SUBJECT: TRAIL RIDGE LANDFILL CONSTRUCTION, PHASE 6, CLASS 1 CELL EXPANSION

SUBJECT: **Trail Ridge Landfill Phase 6 Class 1 Cell Expansion Change Order #3**

CITY OF JACKSONVILLE
DEPARTMENT OF PUBLIC WORKS
ENGINEERING DIVISION
CONSTRUCTION CHANGE ORDER

TRAIL RIDGE LANDFILL PHASE 6 EXPANSION PROJECT
CITY OF JACKSONVILLE PROJECT NUMBER PWSW44K 38484
BID NO: CP-0070-15
CHANGE ORDER No.3

LIMITS OF
SACRIFICIAL LINER
APRIL 2016

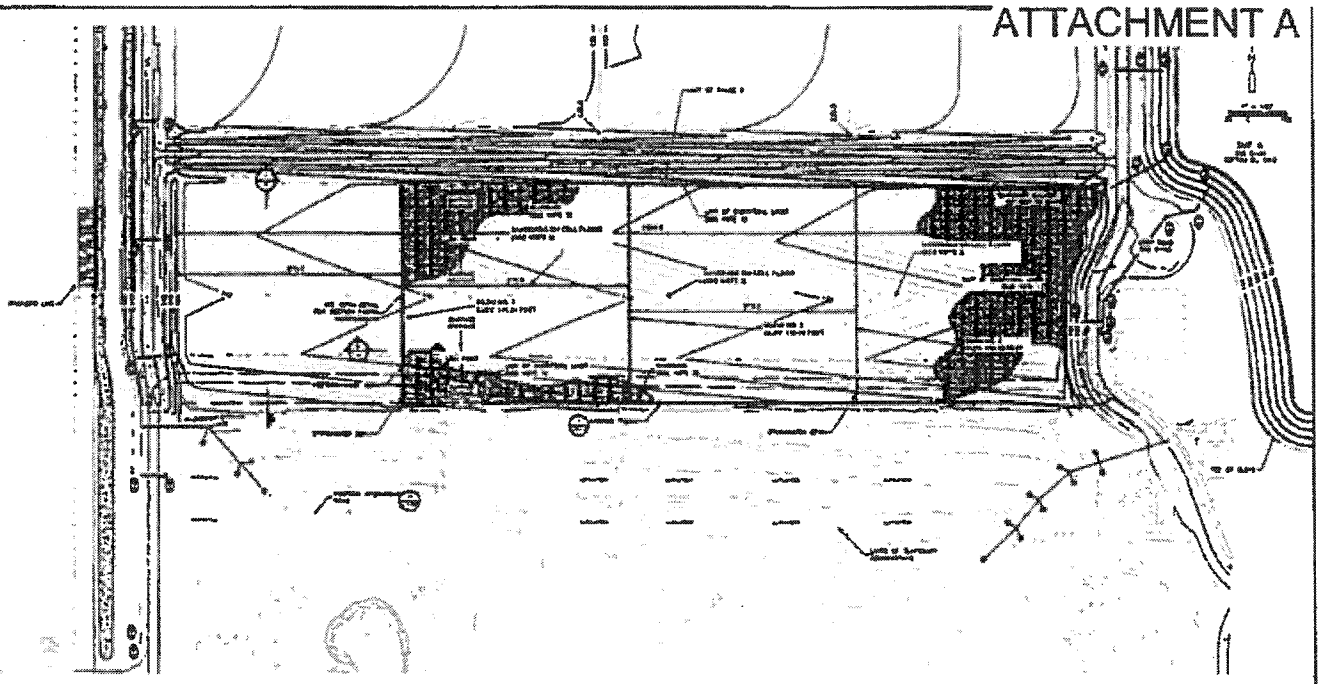
ATTACHMENT A

1. THE LINE OF TEMPORARY 8 MIL SCRIM REINFORCED POLYETHYLENE CLOTHBARRIER (SACRIFICIAL LINER) SHALL BE INSTALLED AS THE LIMITS OF NEW PHASE 6 AS FOLLOWS.

A. FOR THE SOUTHERN EDGE OF NEW PHASE 6, LINER SHALL EXTEND TO THE BOTTOM OF THE TEMPORARY STORMWATER SWALE. (SEE SHEET C0-3A OF CONTRACT DOCUMENTS)

B. FOR THE EAST EDGE OF NEW PHASE 6, LINER SHALL EXTEND TO THE TOP OF THE PROPOSED ANCHOR BERM.

C. FOR THE WEST EDGE (WESTERN MOST BERM), LINER SHALL BE ANCHORED AS SHOWN ON SACRIFICIAL LINER SECTIONS DETAILED IN JANUARY 29' 5.

D. FOR THE NORTHERN EDGE OF PHASE 6, LINER SHALL EXTEND TO TOP OF INTERNAL BERM.

2. THE TEMPORARY CLOTHBARRIER COVER SHALL BE ANCHORED WITH SANDBAGS (SANDBAGS CAN BE SPACE ON 10' CENTERS). SANDBAGS SHOULD HAVE A 3 YEAR MINIMUM UV RATING AND SHALL BE TIED OFF USING 1/8" NYLON ROPE EACH WAY (ROPE LINES NOT REQUIRED ON CELL FLOOR)

3. FOR THE OF THE CELL AREA, CONTRACTOR SHALL ANCHOR WITH FIRE SANDBAGS (NO NYLON ROPES). SANDBAGS SHALL BE SPACED ON 10' CENTERS.

4. CONTRACTOR SHALL PROVIDE COMPACTION TESTING ON INTERMEDIATE SAND BERMS IN ACCORDANCE WITH THE CONTRACTOR SPECIFICATION REQUIREMENTS FOR COMMON FILL. THE METHOD OF COMPACTION AND PROCEDURES SHALL BE SUCH THAT NO DAMAGE IS INCURRED ON THE EXISTING LINER SYSTEM AND 2 FEET OF PROTECTIVE SAND LAYER. CONTRACTOR SHALL SUBMIT TO ENGINEER A DETAILED PLAN OF COMPACTION FOR REVIEW AND APPROVAL PRIOR TO COMMENCEMENT

5. CONTRACTOR SHALL NOTIFY RESIDENT PROJECT REPRESENTATIVE OF VISUAL INSPECTION OF ALL SEAMS AND SANDBAGS BELOW WITH CITY OF JACKSONVILLE, ENGINEER AND WRA

6. CONTRACTOR SHALL SURVEY ASBUILT THE CONTRACTED INTERMEDIATE SAND BERMS. THE SURVEY SHALL INCLUDE INSTALLED CONDITIONS WITH TOPOGRAPHIC ELEVATIONS AT THE BERM TOE AND TOP AT 100-FOOT SPACING (VERIFICATION THAT THE 1V 3H SLOPE IS MAINTAINED AND TOP OF BERM ELEVATIONS)

SACRIFICIAL LINER SECTIONS
APRIL 2014

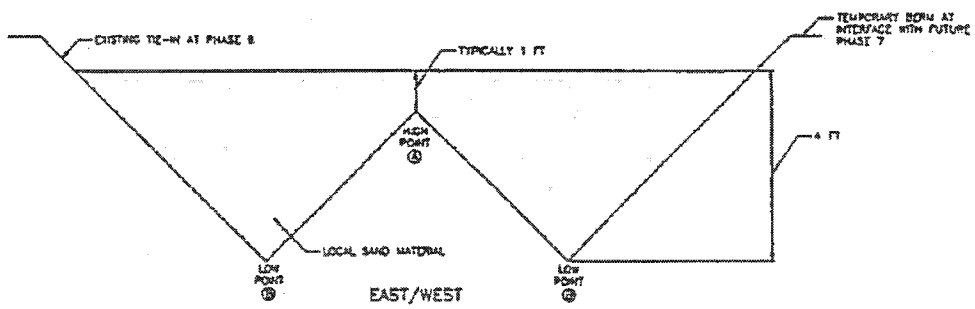
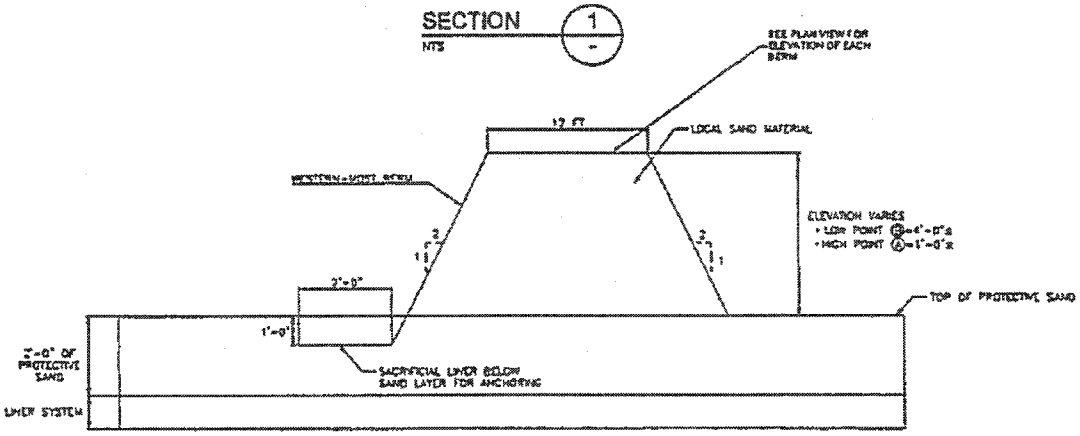
- Three (3) intermediate rain berms shall be constructed (as shown in Attachment A). They shall be comprised of local sand material (meeting common fill specifications). The berm quantity is approximately 4,395 cubic yards and shall be constructed with an approximate 1V:2H slope. The top of the berm shall be constructed with 12-foot width.

- The westernmost sub-cell shall be constructed separately from the remaining three-subcells. It shall be used as the first active filling area for WMI during the initial filling of Phase 6. The sacrificial liner in this location shall be anchored by sandbags along the north face of the existing cell, cell floor and perimeter berms. Once WMI begins filling operation, this will be peeled back to the north.

- The intermediate rain berms shall be constructed to an elevation of typically 1-foot above the high point in the cell, denoted as "Point A" in East/West Section 1 of the berm in Attachment A. The elevations of these berms shall be:

- Berm No. 1 (Westernmost): 141.24 feet EL
    - Bern No. 2 (Middle): 136.00 feet EL
    - Berm No. 3 (Easternmost): 130.03 feet EL
- Intermediate berms shall be compacted by the Contractor for WMI operations (light truck) traffic. Soil surface shall be firm and unyielding. The method of compaction and procedures

- Contractor shall provide the necessary anchoring system and sandbags, as shown in Attachment A. For the perimeter anchoring, the Contractor shall anchor sandbags as 8-foot on-center and tied off using 3/8" nylon rope. For anchoring in the cell floor, Contractor shall place sandbags at 40-foot on-center pattern across the entire footprint covered by the sacrificial liner. All sandbags utilized for the sacrificial liner anchoring shall be 50 pounds.
